Access Compliance Report

Public Rights-of-Way

(Curb Ramps)

Intersection ID: 10025367	Main Street: E_8TH_ST	Cross Street: N/A	Location: W
ADA ID: 223A6548AFC9	Ramp Type: Perp	Initial Pass/Fail: Pass	Overall Compliance: No
Severity Score: 17.5			
Codes/Mitigation Info/Possible Solution		Field Measurements/Component Compliance

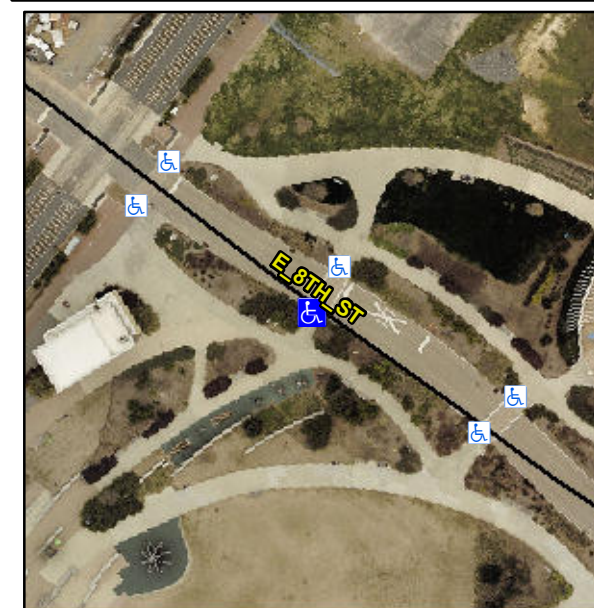
**R304.2.2-Perp, R304.3.2-Para,
R305.1.4, R302.7.2**

Compliance	Description	Data	Compliance	Description	Data
N/A	Ramp Length (in)	92.0	Yes	Ramp Slope (%)	5.3
Yes	Ramp Width (in)	64.0	Yes	Ramp XSlope (%)	0.5
N/A	Flare Type LT	None	N/A	Flare Type RT	N/A
N/A	Flare Slope LT (%)	N/A	N/A	Flare Slope RT (%)	N/A
N/A	Flare Traversable LT?	N/A	N/A	Flare Traversable RT?	N/A
Yes	Landing Length (in)	48.0	Yes	DWS Provided?	Yes
Yes	Landing Width (in)	48.0	Yes	DWS Contrast?	Yes
No	Landing Slope (%)	2.4	Yes	DWS Length (in)	24.0
Yes	Landing X Slope (%)	0.8	No	DWS Full Width?	No
N/A	Landing Curb? (Y/N)	No	Yes	DWS Offset (in)	0.0
N/A	Shared Landing?	No			
Yes	Gutter Ponding?	No	Yes	Gutter Slope (%)	0.3
No	Gutter Lip Ht (in)	0.8	Yes	Gutter X Slope (%)	1.9
N/A	Painted X Walk1?	Yes	N/A	Painted X Walk2?	N/A
	X Walk 1 Direction	To NE		X Walk 2 Direction	N/A
N/A	X Walk 1 Width (in)	120.0	N/A	X Walk 2 Width (in)	N/A
	X Walk 1 Slope (%)	0.8		X Walk 2 Slope (%)	N/A
	X Walk 1 X Slope (%)	3.2		X Walk 2 X Slope (%)	N/A

**Remove & Replace Entire Ramp.
Grind Gutter Lip.**
